[EPA-R08-OAR-2018-0606; FRL-9992-73-Region 8]

Approval and Promulgation of Air Quality Implementation Plans; Wyoming; Revisions to Regional Haze State Implementation Plan; Revisions to Regional Haze Federal Implementation Plan

ACTION: Final rule.

Figure 1. Map Depicting Federal Class I Areas and Representative IMPROVE Monitors in Wyoming.

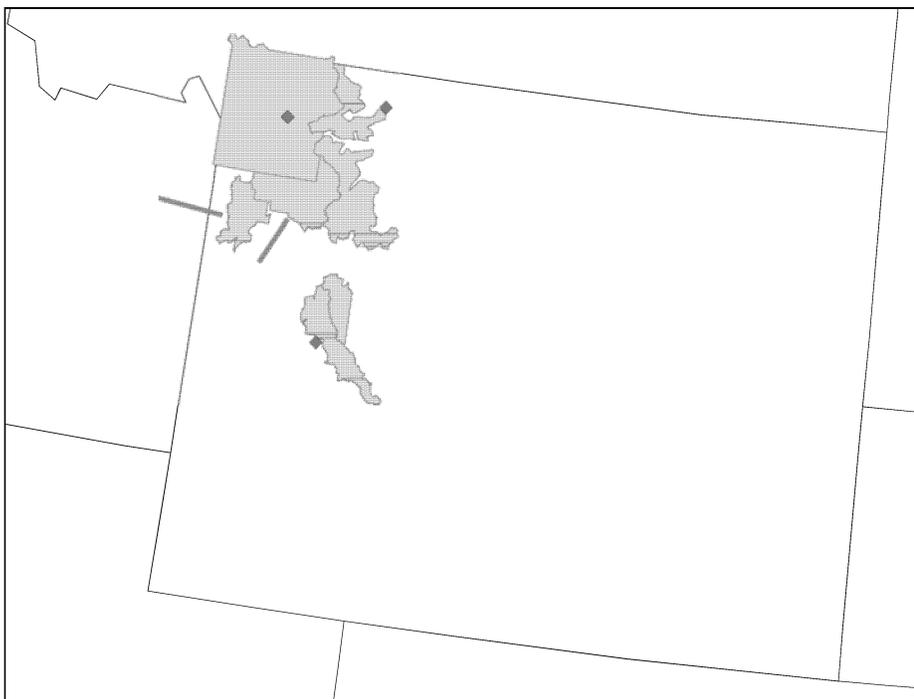
Comment: Finally, the commenters argue that multiple features of the EPA’s modeling exacerbate the uncertainty inherent in CAMx and compound the unreliability of the results on which the EPA relies upon in its BART alternative determination, including:⁹⁸

Response: We disagree with the commenters’ arguments that multiple features of our modeling, including large transport distances, lack of IMPROVE monitors, and the use of PSAT exacerbated the uncertainty inherent in CAMx and compounded the unreliability of the results on which we relied upon in our BART alternative determination. In fact, we utilized multiple tools, as discussed previously, to further evaluate the modeling results to determine whether the results represent “real” modeled visibility differences.

Specifically, it is true that in some geographic areas, single IMPROVE monitors represent multiple Class I areas, based on expected similarities between the airsheds (Figure 1). This
